**DOCUMENT 00 91 13 A2  
ADDENDUM 2**

Addendum 2

ROCK CANYON AQUIFER STORAGE  
BOOSTER STATION & TRANSMISSION LINE, BID SCH 2

BARR PROJECT No.	
44251024.00	
CLIENT PROJECT No.	
PROVOEN202320182	
DWG. No.	REV. No.
C-011	B

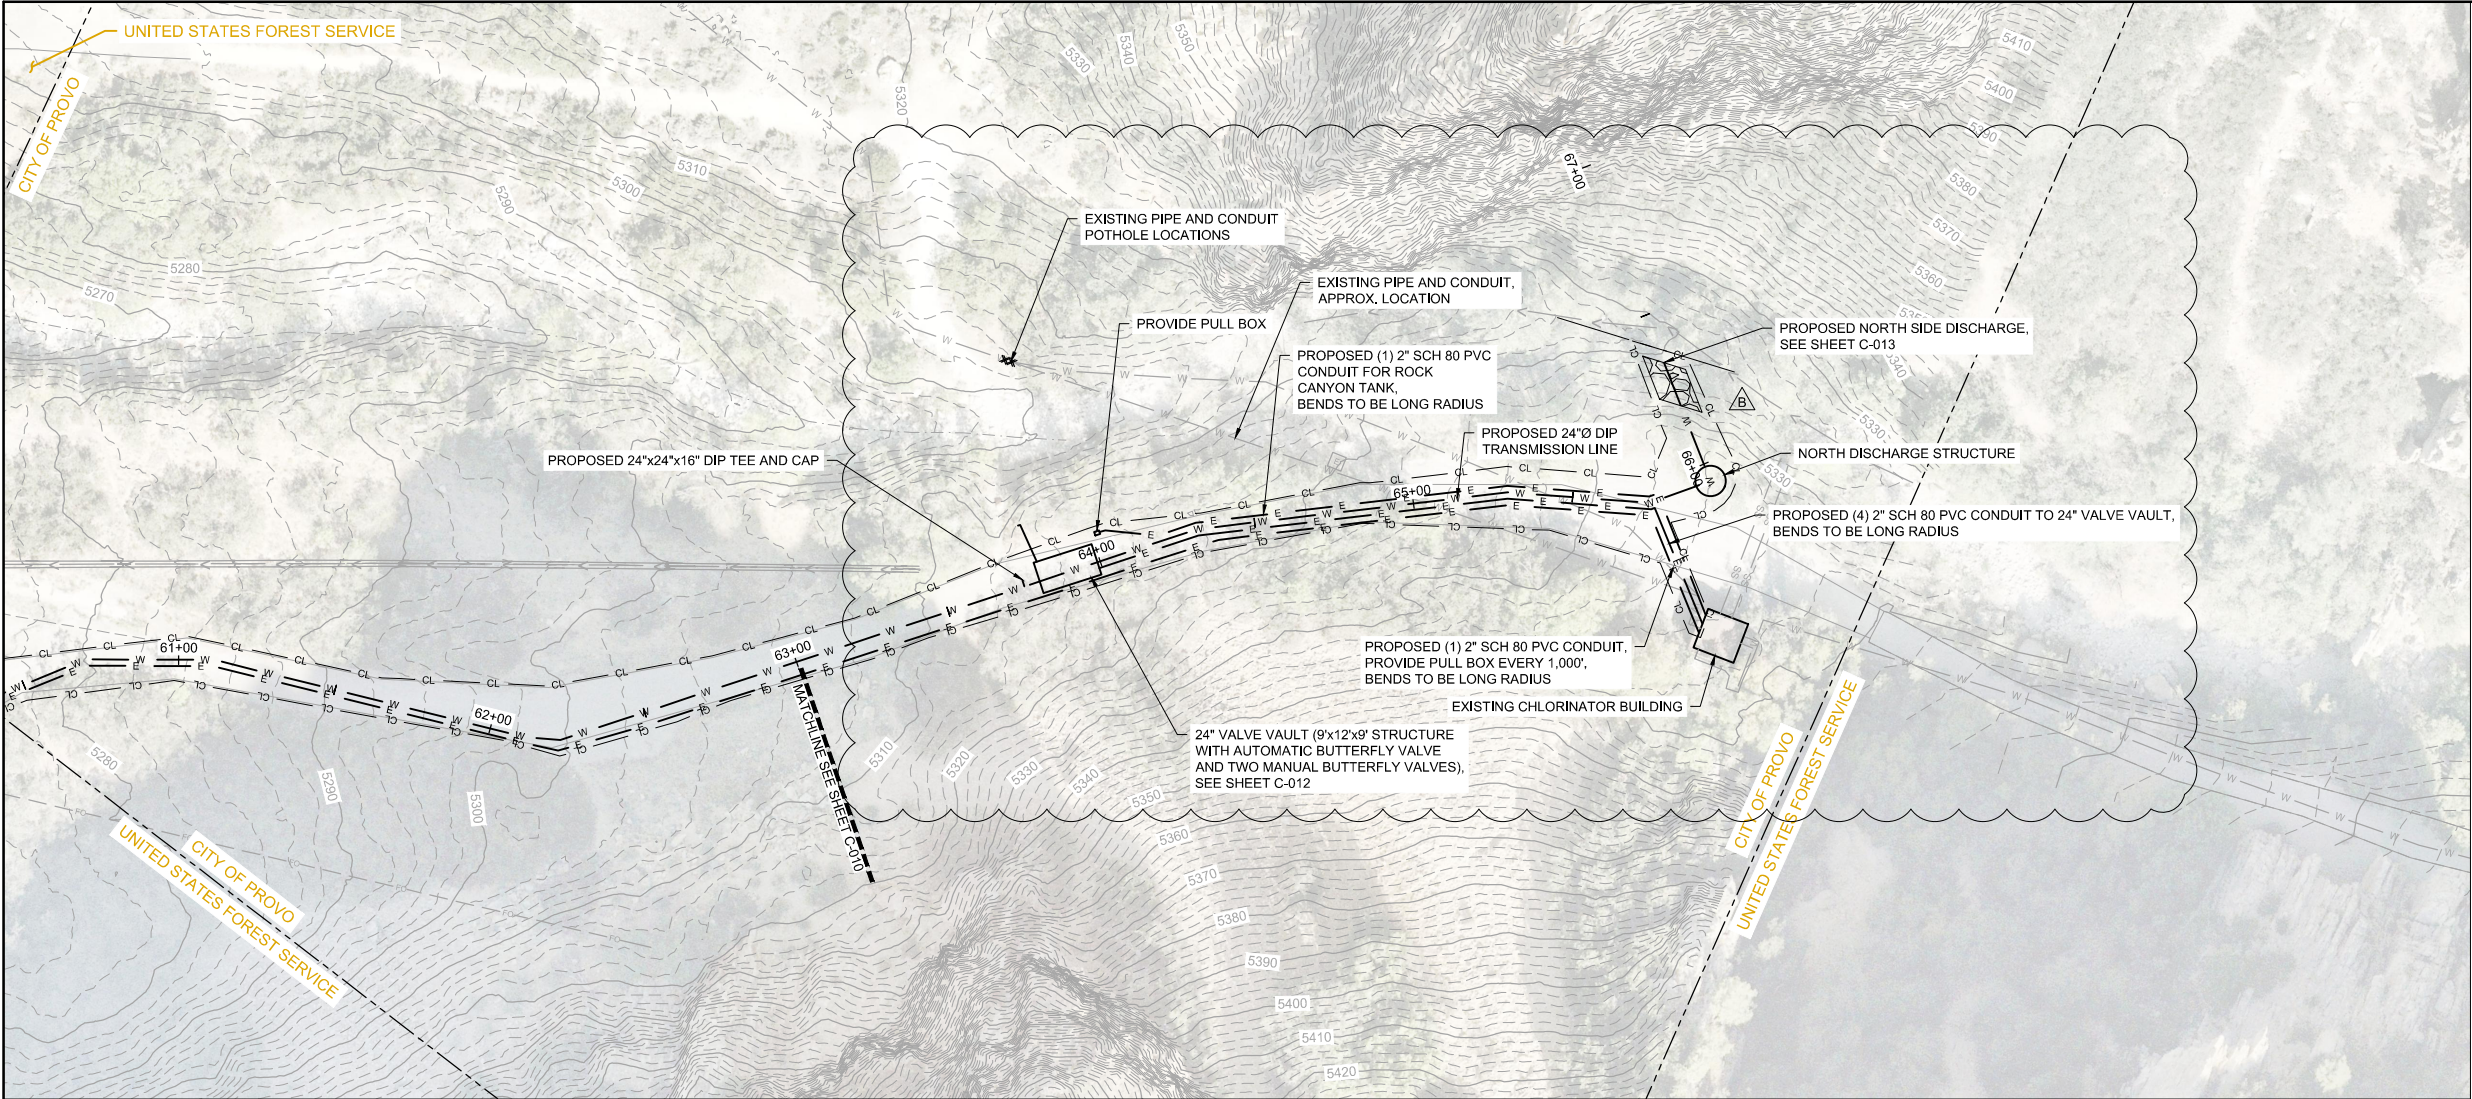
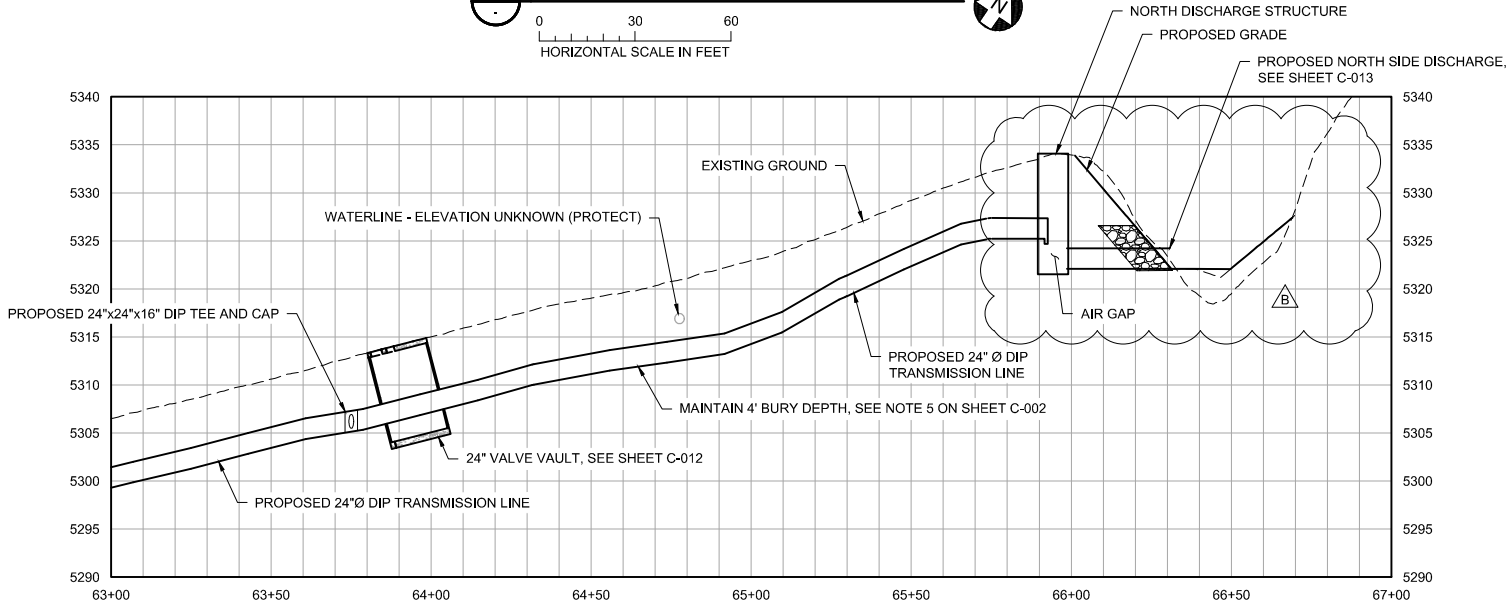
- A. Delete Drawings C-011 Rev A, and C-013 Rev A in their entirety and replace them with Drawings C-011 Rev B, and C-013 Rev B. These replacement Drawings are attached to this Addendum 2.
- B. The effect of this change is to modify the North Side Discharge by reducing the disturbed area and reducing the riprap requirements and to clarify the seismic restrained joint requirements..

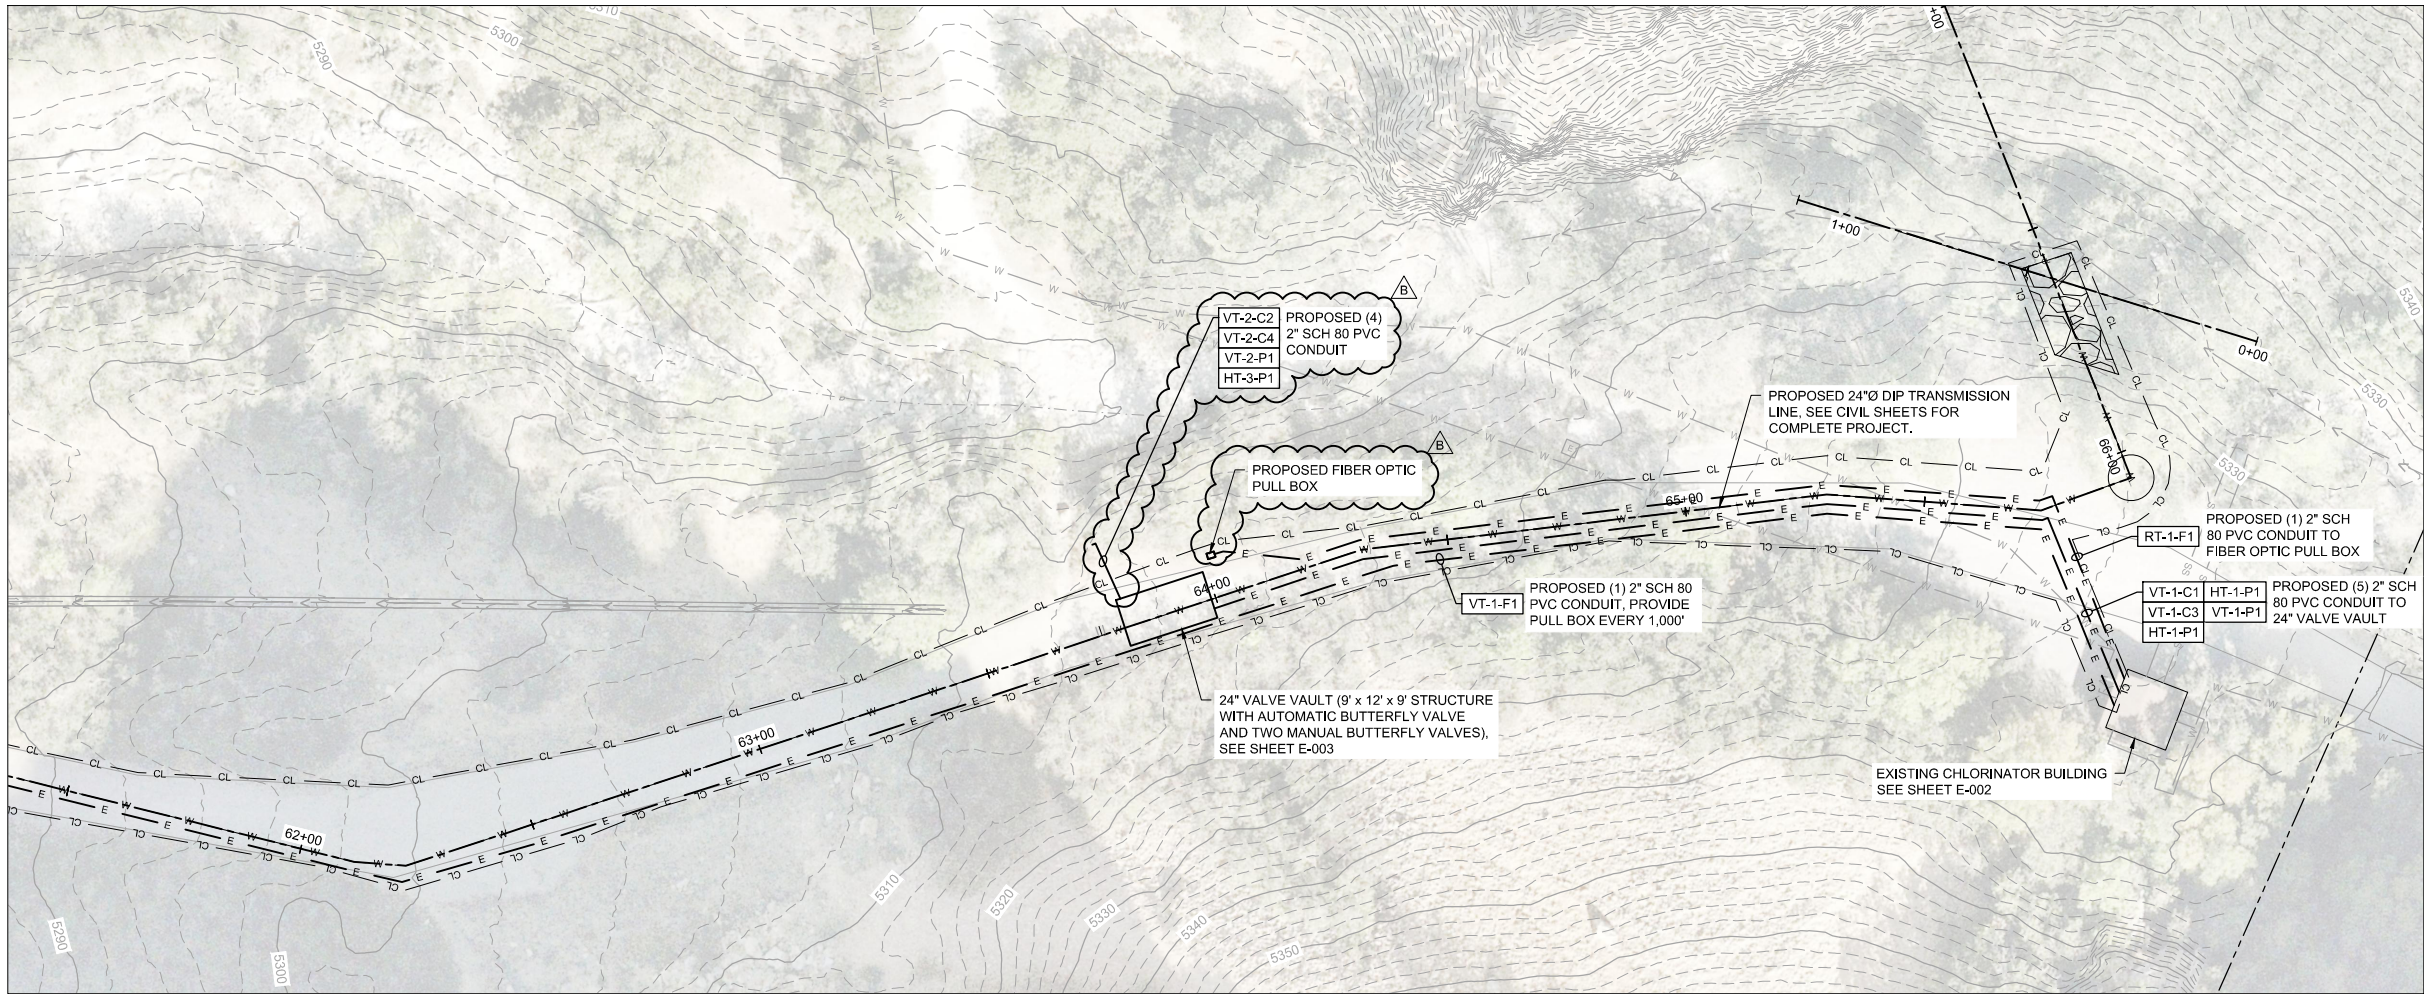
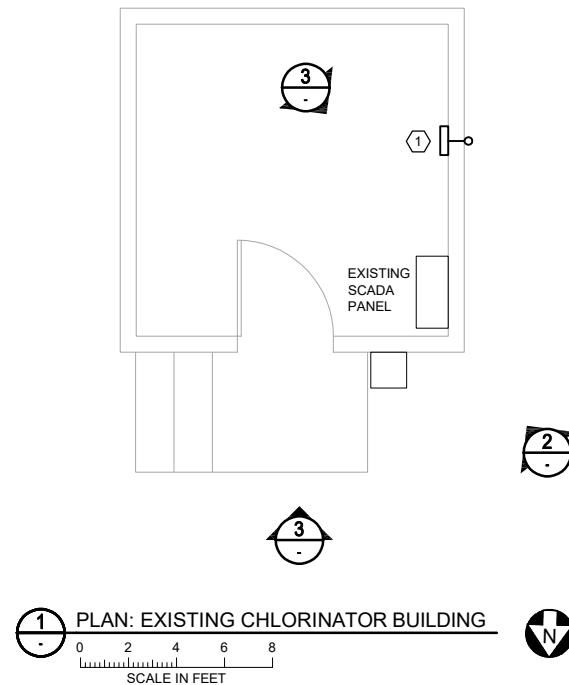
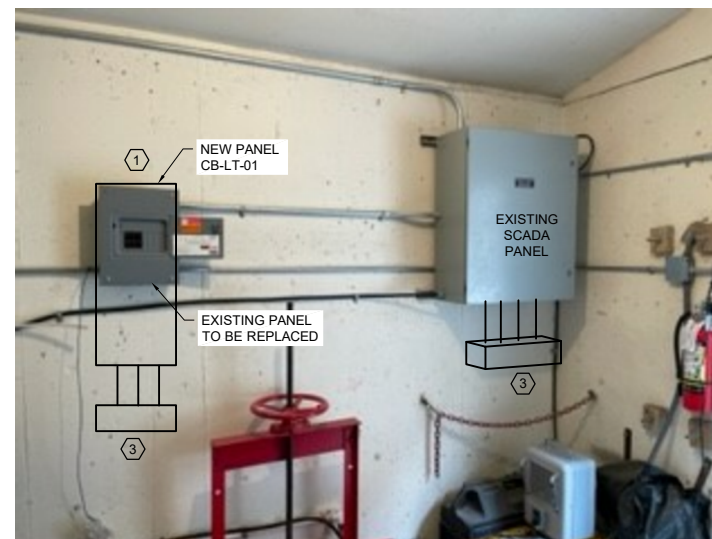
- A. Delete Drawings E-001 Rev A, E-002 Rev A, E-003 Rev A, and E-005 Rev A in their entirety and replace them with Drawings E-001 Rev B, E-002 Rev B, E-003 Rev B, and E-005 Rev B. These replacement Drawings are attached to this Addendum 2.
- B. The effect of this change is to clarify the electrical and conduit requirements at and around the transmission line 24" valve vault (near Station 64+00).
